3.3 Wind-and Tornado and Hurricane Loadings

DCD_02-03
S01

MIC-03-03-
00057

3. DESIGN OF STRUCTURES, SYSTEMS, US-APWR Design Control Document COMPONENTS, AND EQUIPMENT

Figure 3.8.1-8 Containment Penetrations (Sheet 13 of 17)

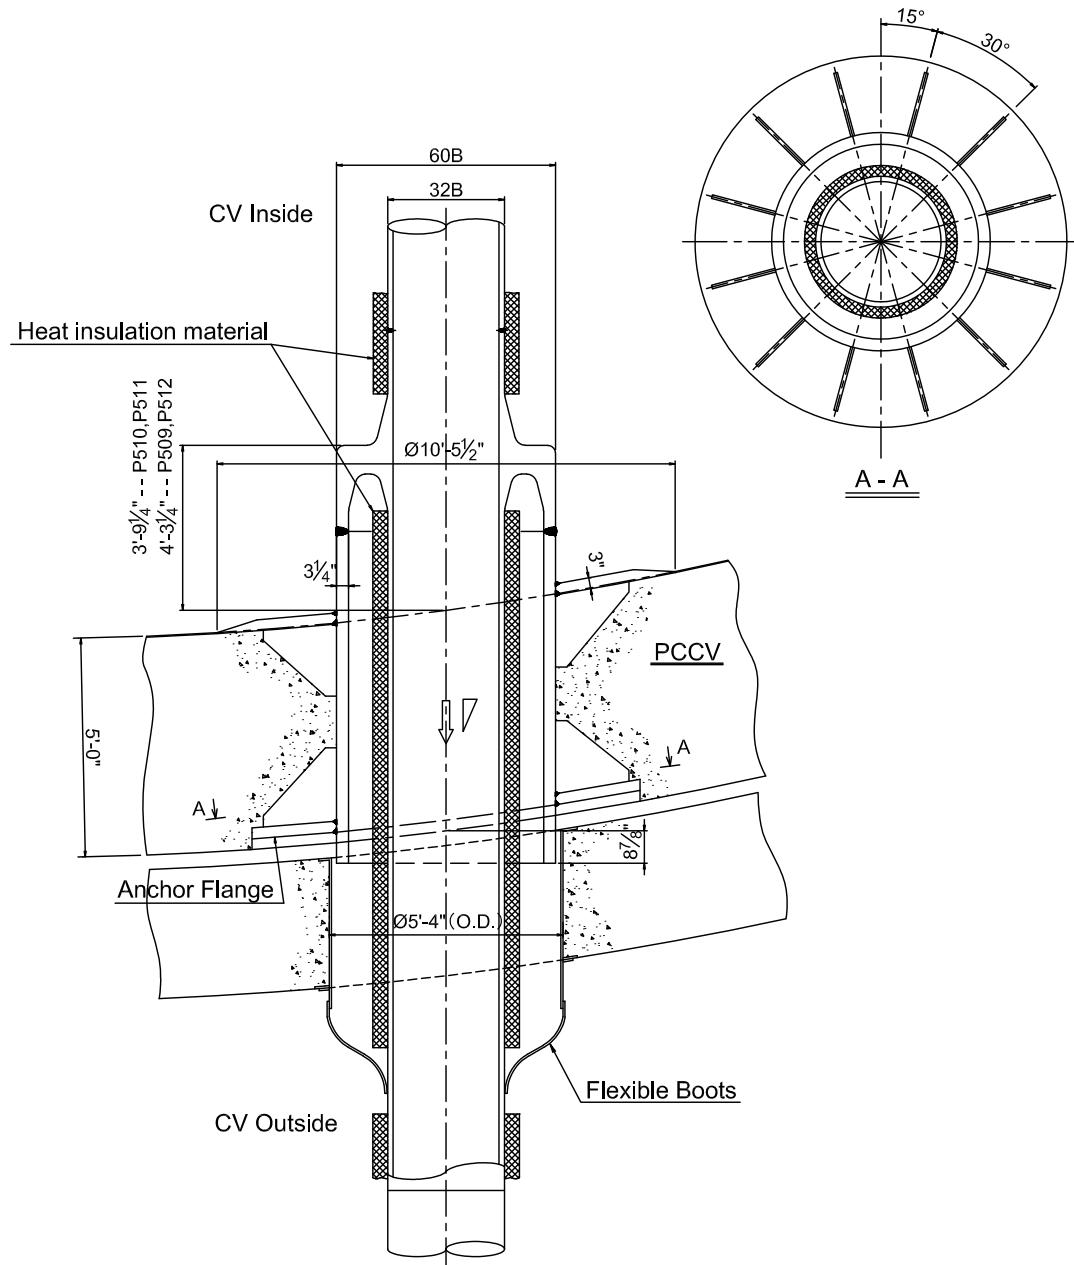
Figure 3.8.1-8, Sheet [1213](#), shows typical details for the main steam penetrations. An anchor flange disc is embedded along the outer surface of the PCCV wall, with 12 triangular gussets at equal spacing connecting the flange disc and a 60 in. Outside Diameter (OD) cylindrical pipe sleeve, which is capped with a flexible boot outside the PCCV. A similar gusset configuration exists at the PCCV inner wall surface connecting the pipe sleeve to the thickened steel liner. The sleeve extends inside containment and is welded to the flued head. The distance from the inner surface of the containment to the flued head is 3 ft, 9-1/4 in. for Loops [AB \(P510\)](#) and [DC \(P511\)](#), and 4 ft, 3-1/4 in. for Loops [BA \(P509\)](#) and [ED \(P512\)](#). The 32 in. OD main steam pipe passes through the sleeve opening.

Figure 3.8.1-8 Containment Penetrations (Sheet 14 of 17)

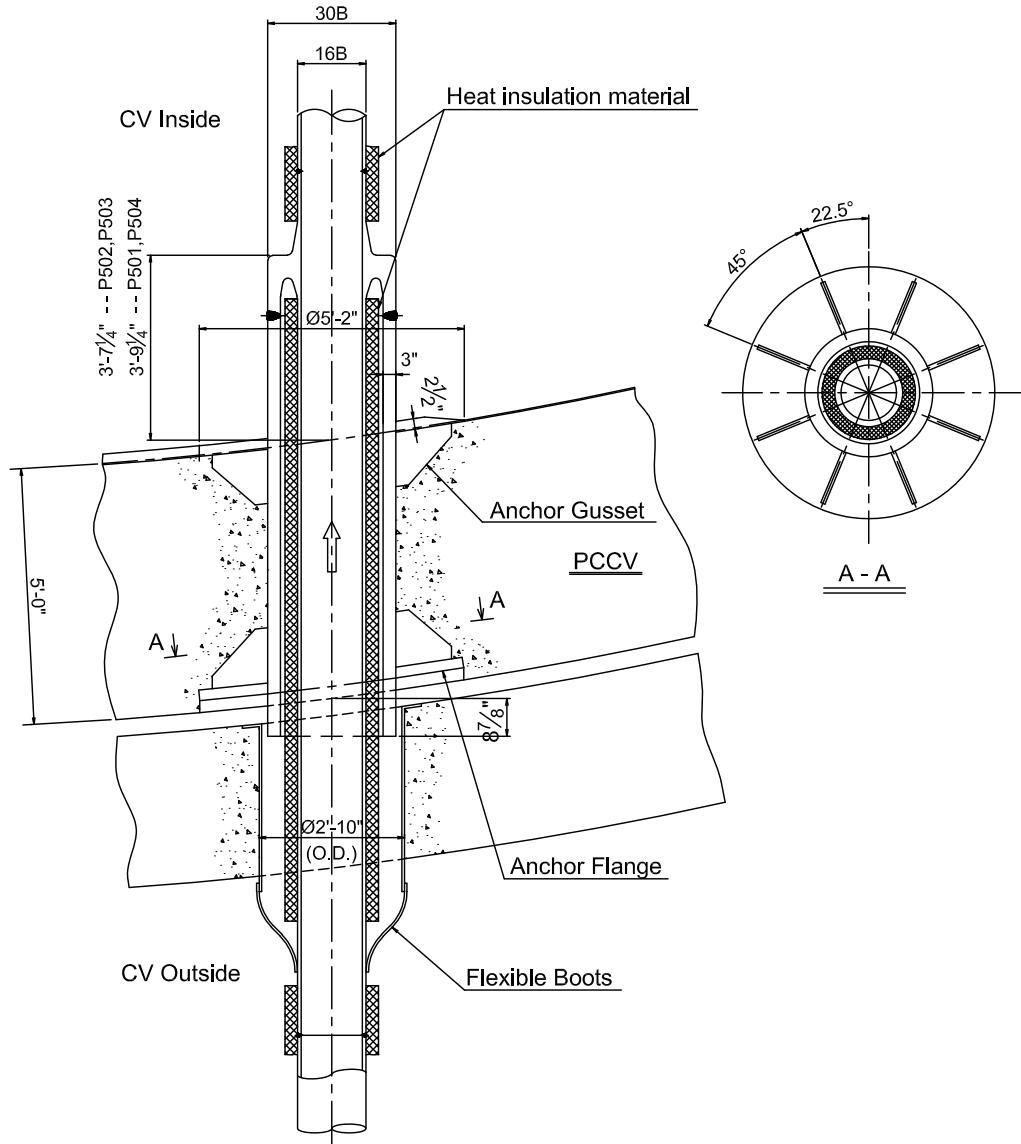
Figure 3.8.1-8, Sheet [1314](#), shows typical details for the startup feedwater penetration. An anchor flange disc is embedded along the outer surface of the PCCV wall, with eight triangular gussets at equal spacing connecting the flange disc and 30 in. OD cylindrical pipe sleeve which is capped with a flexible boot outside the PCCV. A similar gusset configuration exists at the PCCV inner surface connecting the pipe sleeve to the thickened steel liner. The sleeve extends inside containment and is welded to the flued head. The distance from the inner surface of the containment to the flued head is 3 ft, 7-1/4 in. for Loops [AB \(P502\)](#) and [DC \(P503\)](#), and 3 ft, 9-1/4 in. for Loops [BA \(P501\)](#) and [GD \(P504\)](#). The 16 in. OD feedwater supply pipe passes through the sleeve opening. The 4 in. SG blowdown pipe (Figure 3.8.1-8 Sheet [1415](#)) passes through a 14 in. OD pipe sleeve that is anchored in the PCCV wall with four rectangular gussets embedded approximately midway in the wall. The sleeve extends inside containment and is welded to the flued head. The distance from the inner surface of the containment to the flued head is 1 ft, 10-5/8 in. for all loops. The SG blowdown pipe sleeve is capped with a flexible boot outside the PCCV.

Figure 3.8.1-8 Containment Penetrations (Sheet 17 of 17)

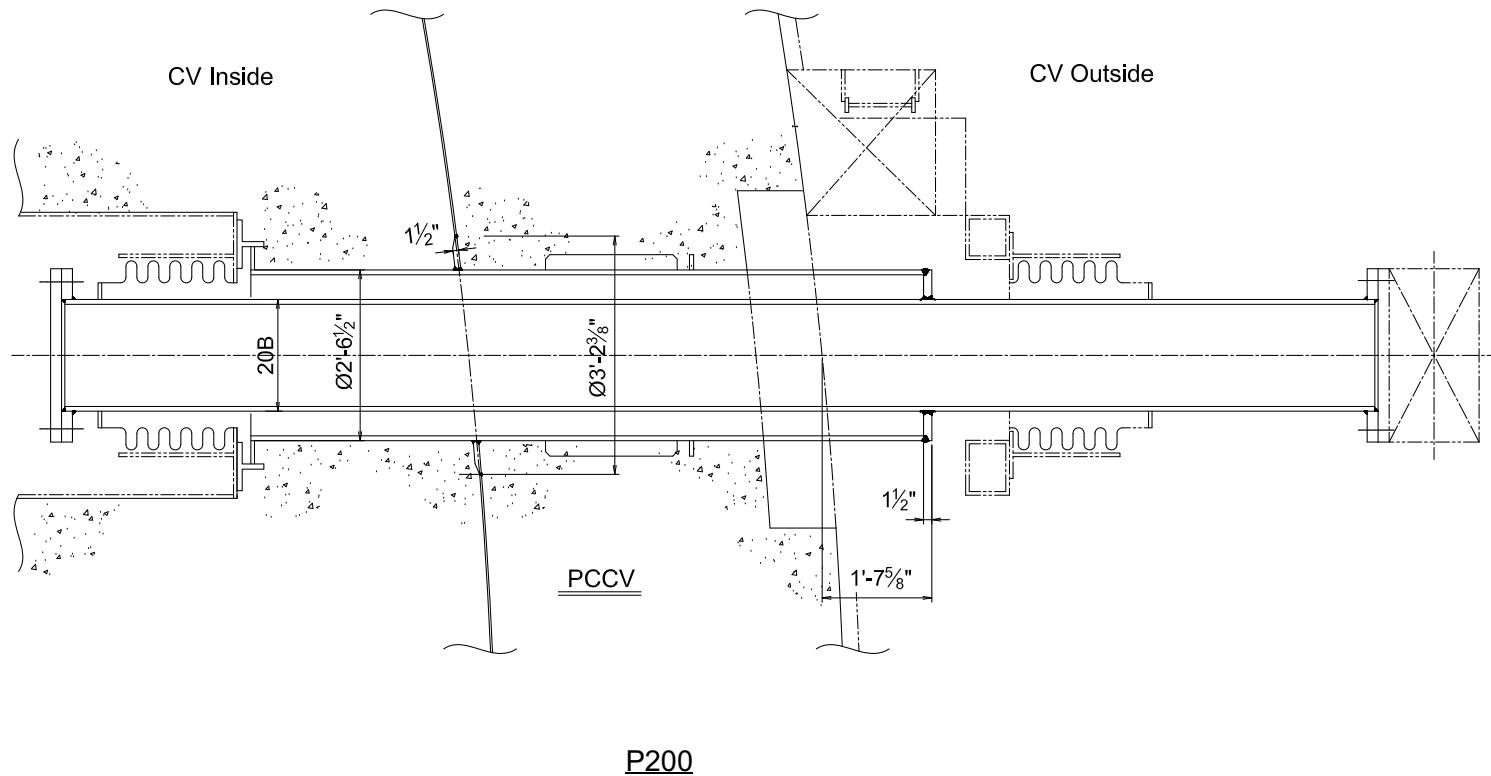
The fuel transfer tube penetrates the PCCV wall near azimuth 0 degrees, connecting the fuel handling canal in the R/B with the refueling canal in the interior of the PCCV. The fuel transfer tube penetration is sealed with the PCCV wall similar to other mechanical penetrations. The containment boundary is a double-gasketed blind flange at the refueling canal end. The expansion bellows are independent of the containment boundary; however, they maintain water seals by accommodating differential movement of the structures. [The fuel transfer tube penetration is shown on Sheet 17 of Figure 3.8.1-8.](#)

Figure 3.8.1-8, Sheets 1 through ~~10, 15, and 17~~5, 7, 8, 11, and 16 show other typical mechanical penetration details. Figure 3.8.1-8, Sheet ~~46~~17, provides the penetration detail of the refueling canal.

**Figure 3.8.4-4 Typical Reinforcement in West Exterior Wall – SECTION 1
(Sheet 1 of 2)**

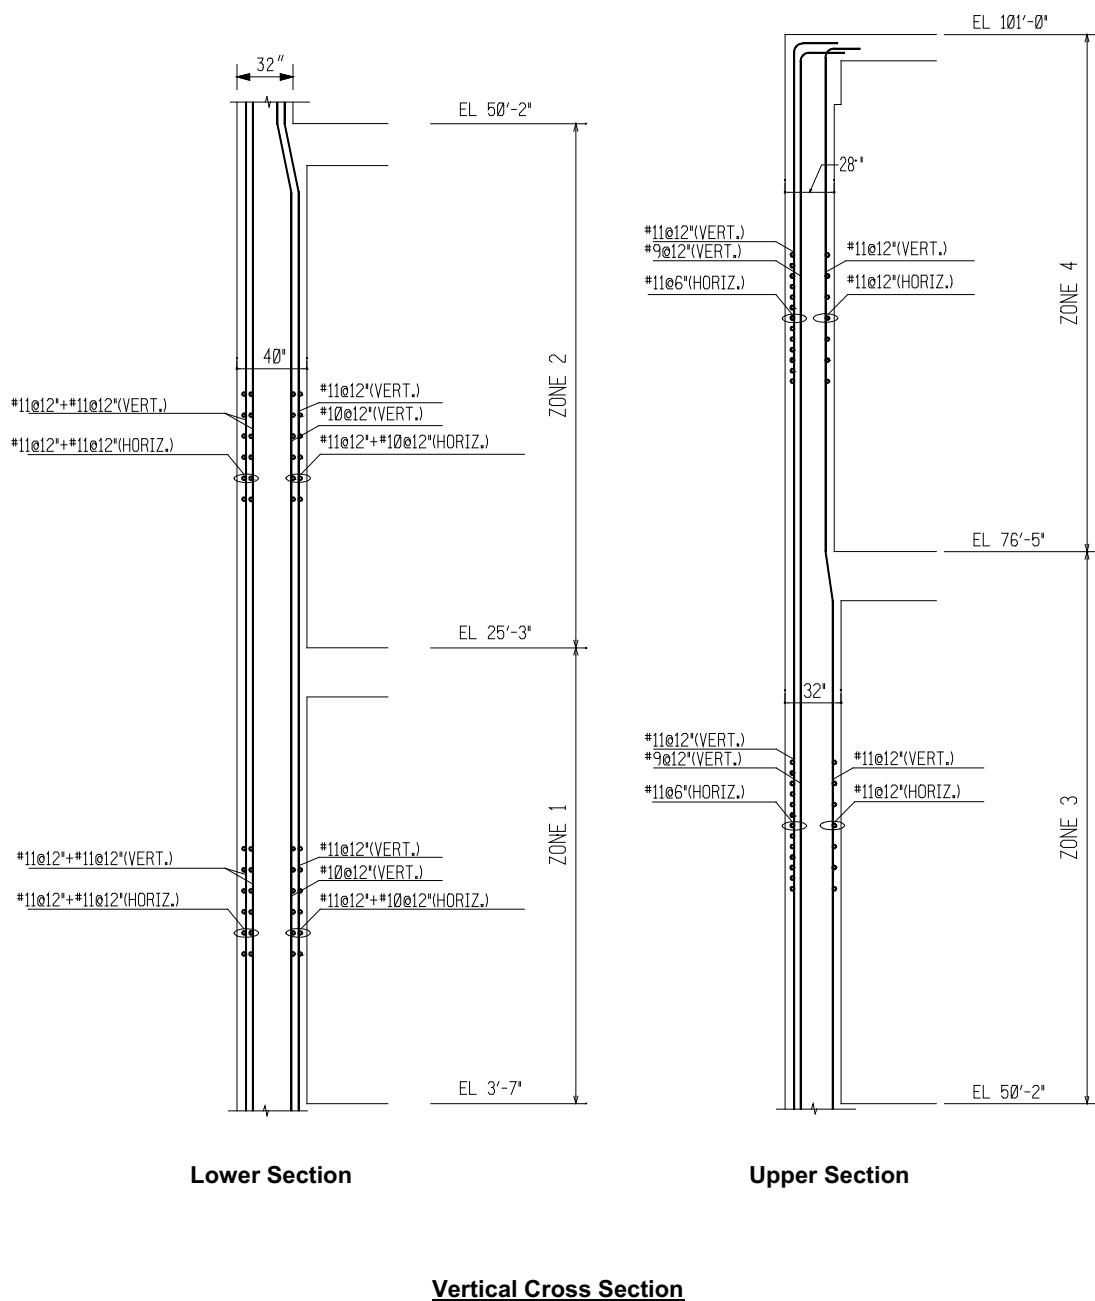
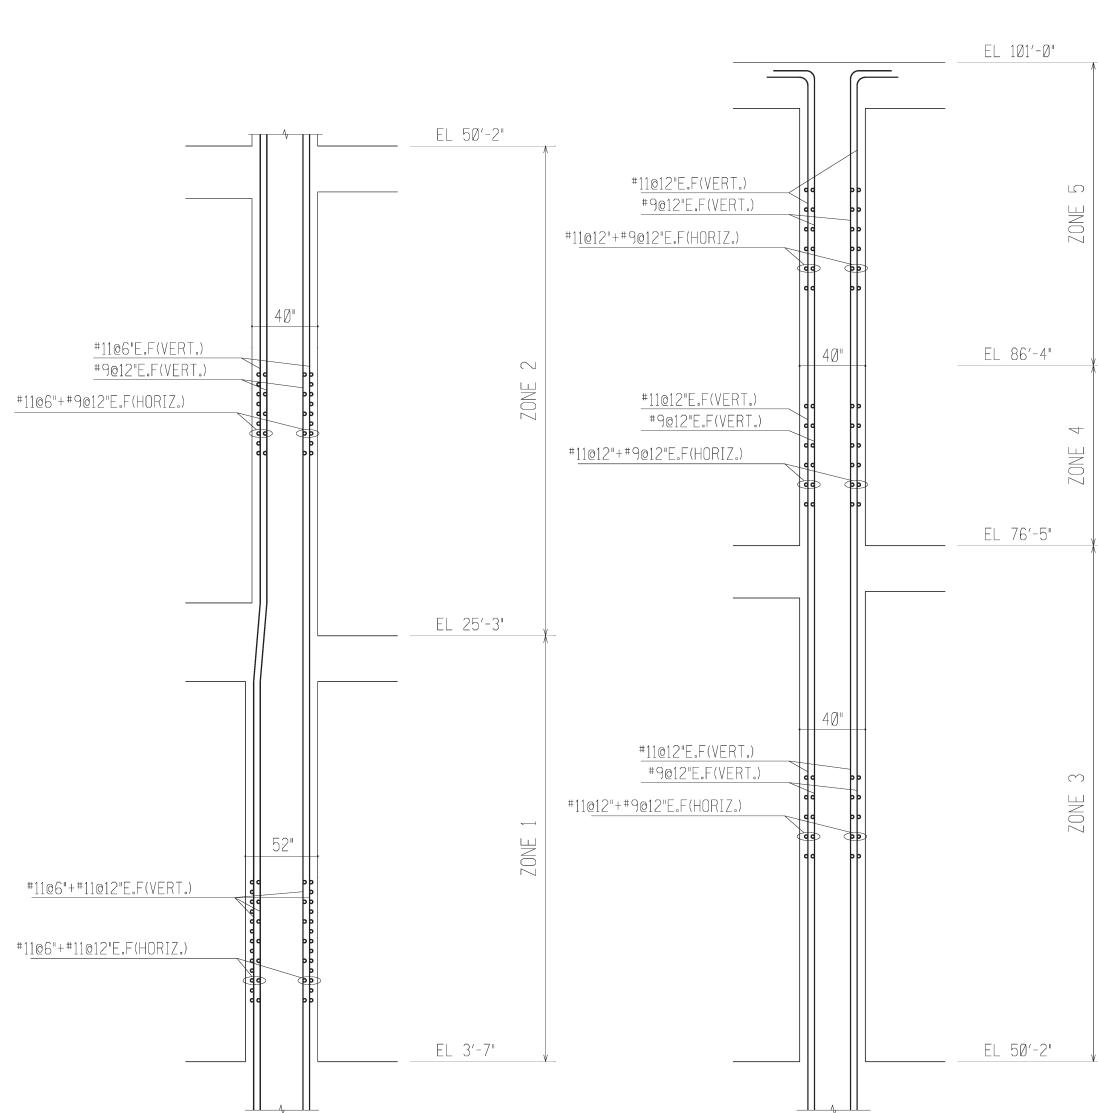
The west ~~exterior~~ reinforced concrete wall is a common wall between R/B and A/B, which extends from ~~the top of the basemat area at~~ elevation 3 ft, 7 in. to the roof at elevation 101 ft, 0 in. The wall is designed as a Category I structure. The wall segments are typically 28 in. to 40 in. thick. The wall is designed for the applicable loads including dead load, live load, and seismic loads, ~~thermal loads, hurricane loads, and tornado missile loads~~. As shown in Figure 3.8.4-4, the wall is divided in 4 segments for design purposes. Table 3.8.4-6 presents the typical details of the reinforcement for each SECTION 1 wall zone. Figure 3.8.4-4 shows the typical reinforcement for the west ~~exterior~~common wall at SECTION 1.

Figure 3.8.4-6 Typical Reinforcement in North Exterior Wall of Spent Fuel Pit – SECTION 3 (Sheet 1 of 2)

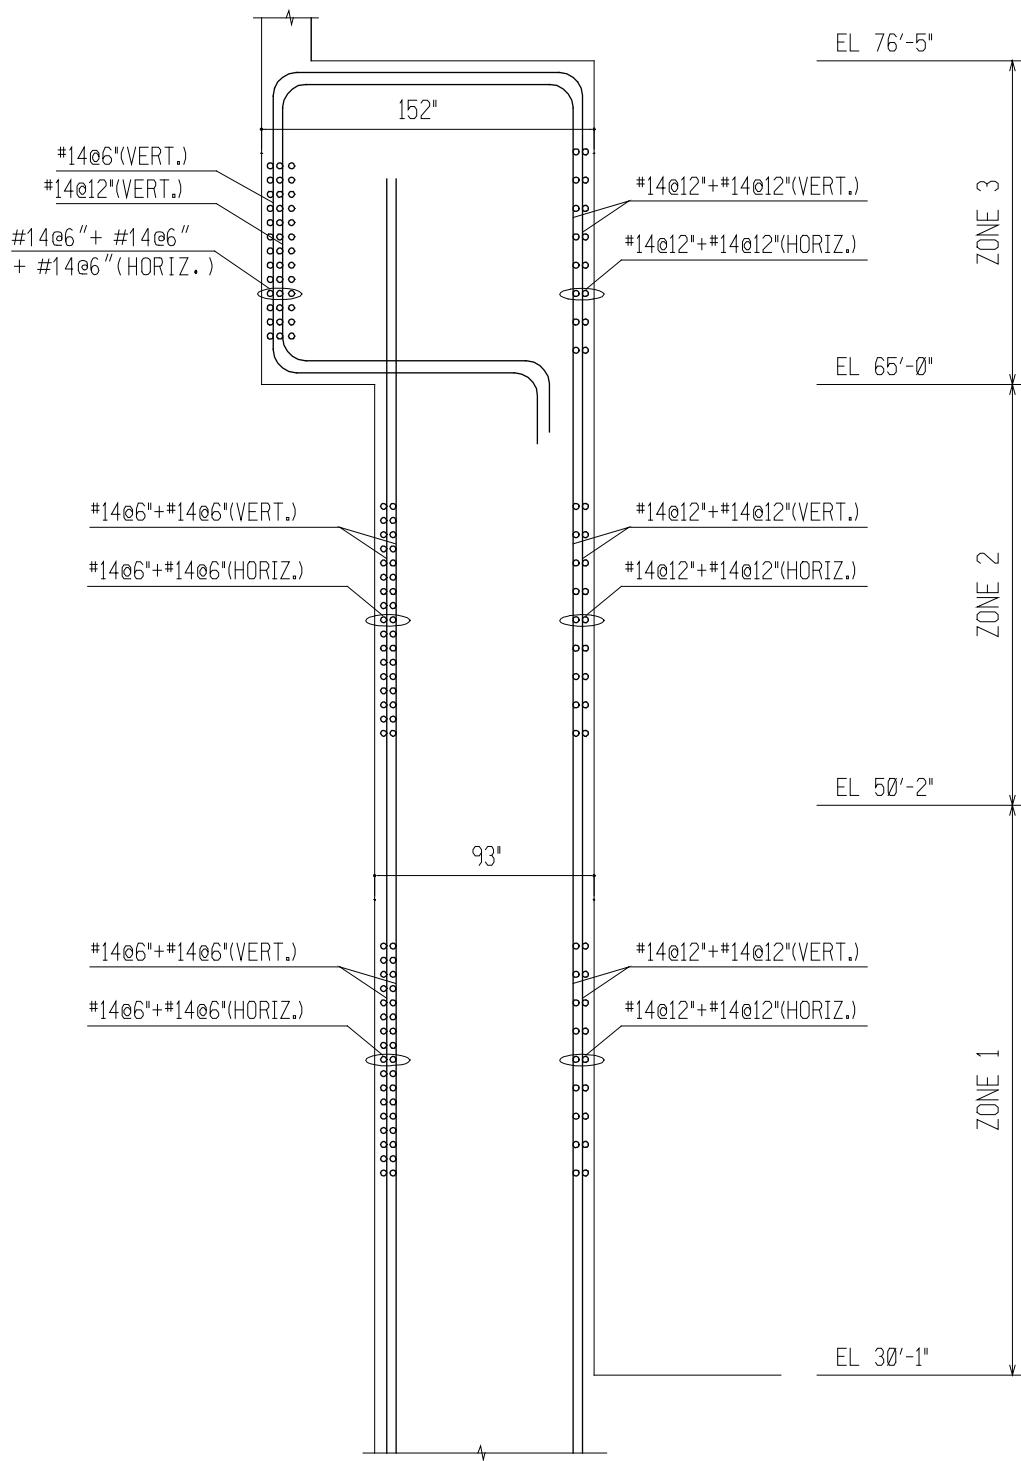
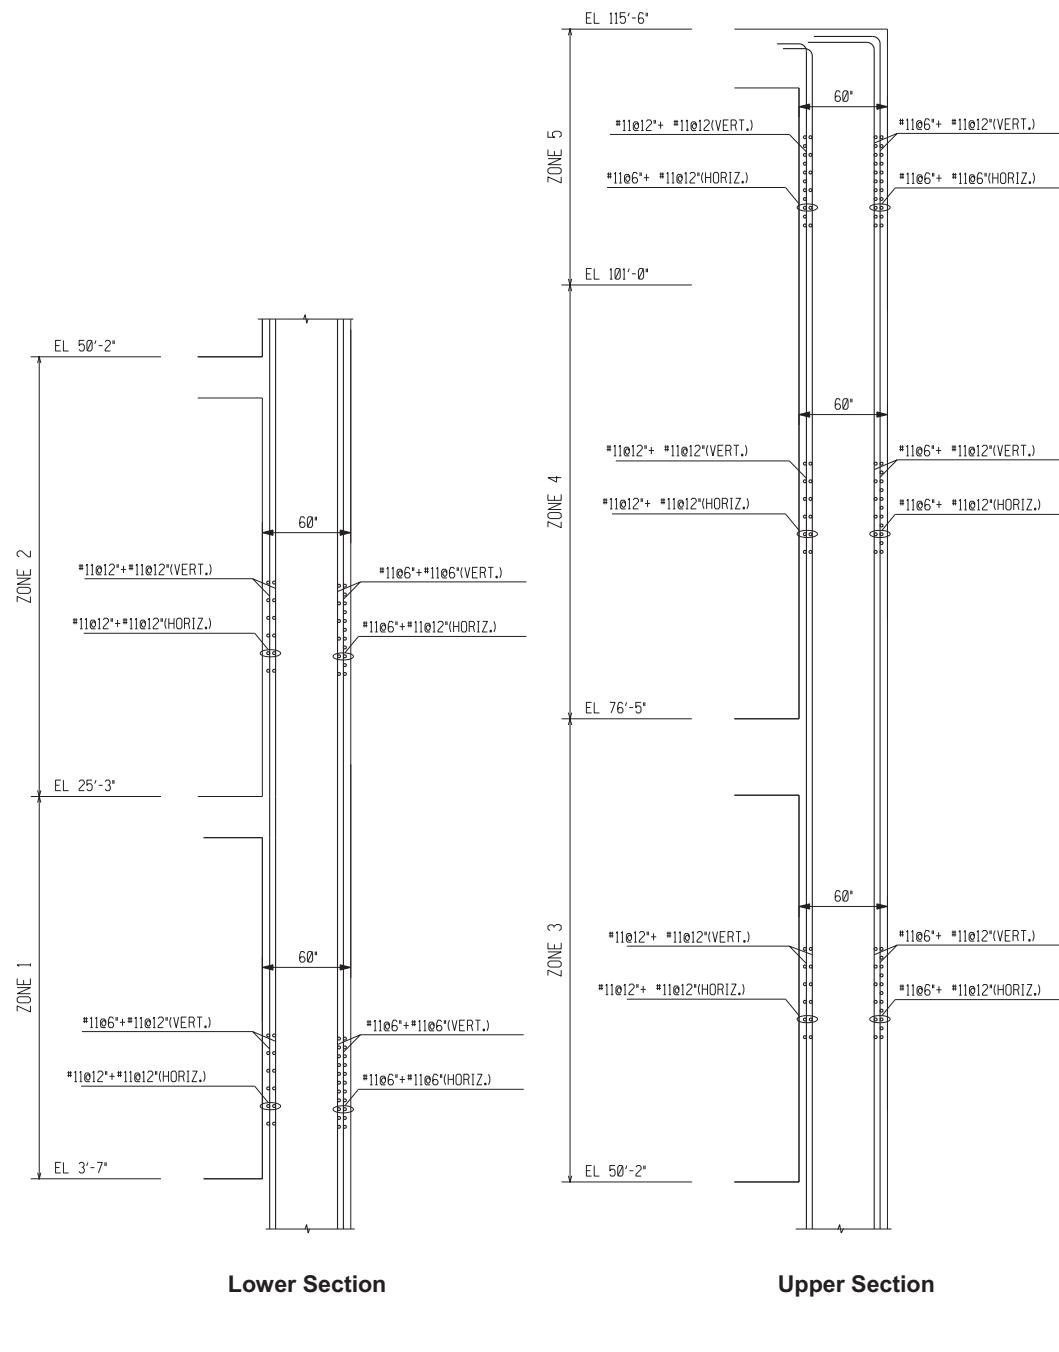
The north exterior reinforced concrete wall of the spent fuel pit extends from elevation 30 ft, 1 in. to the roof at elevation 76 ft, 5 in. The wall segments are typically 93 in. to 152 in. thick. The wall is designed for the applicable loads including dead load, live load, hydrostatic and hydrodynamic loads, seismic loads, spent fuel rack reaction loads, and thermal loads. As shown in Figure 3.8.4-6, the wall is divided in 3 segments for design purposes. Table 3.8.4-8 presents the typical details of the reinforcement for each SECTION 3 wall zone. Figure 3.8.4-6 shows the typical reinforcement for the ~~west~~north exterior wall at SECTION 3.

**Figure 3.8.4-7 Typical Reinforcement in South Exterior Wall – SECTION 4
(Sheet 2 of 2)**

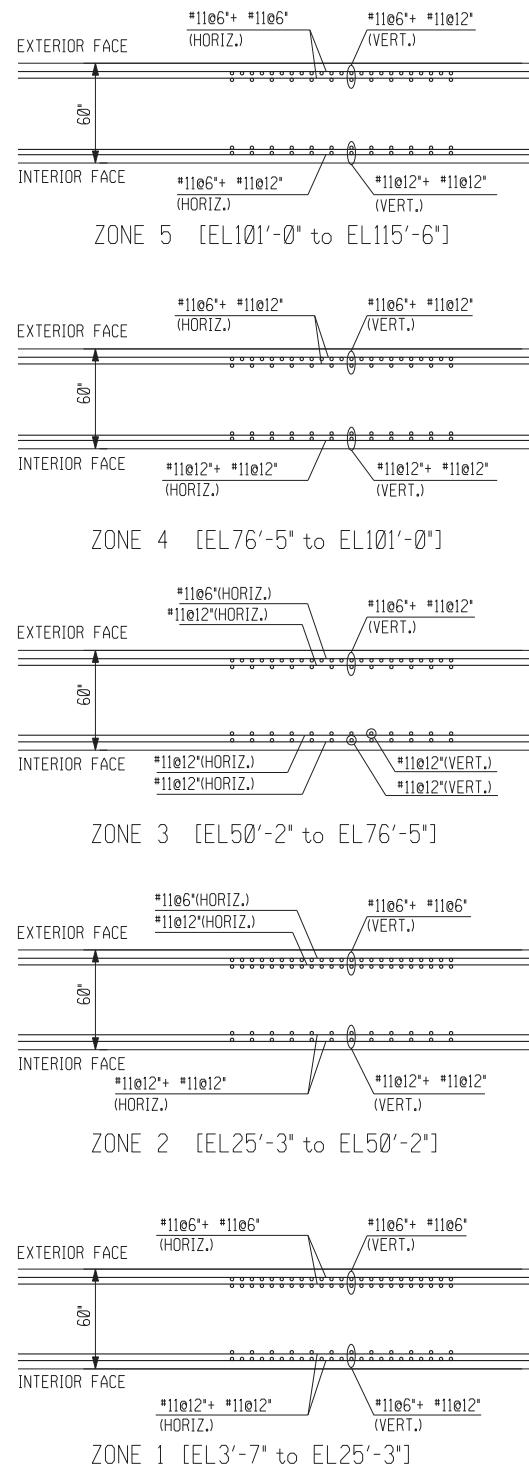
The south exterior reinforced concrete wall extends from ~~the top of the basemat area at~~ elevation 3 ft, 7 in. to the roof at elevation 115 ft, 6 in. The wall segments are typically 4~~60~~ in. ~~to 44 in.~~ thick. The wall is designed for the applicable loads including dead load, live load, hydrostatic and hydrodynamic loads (for Emergency Feedwater Pit wall), seismic loads, thermal loads, ~~and tornado missile lead~~tornado loads and hurricane loads. As shown in Figure 3.8.4-7, the wall is divided in 5 segments for design purposes. Table 3.8.4-9 presents the typical details of the reinforcement for each SECTION 4 wall zone. Figure 3.8.4-7 shows the typical reinforcement for the ~~west~~south exterior wall at SectionSECTION 4.
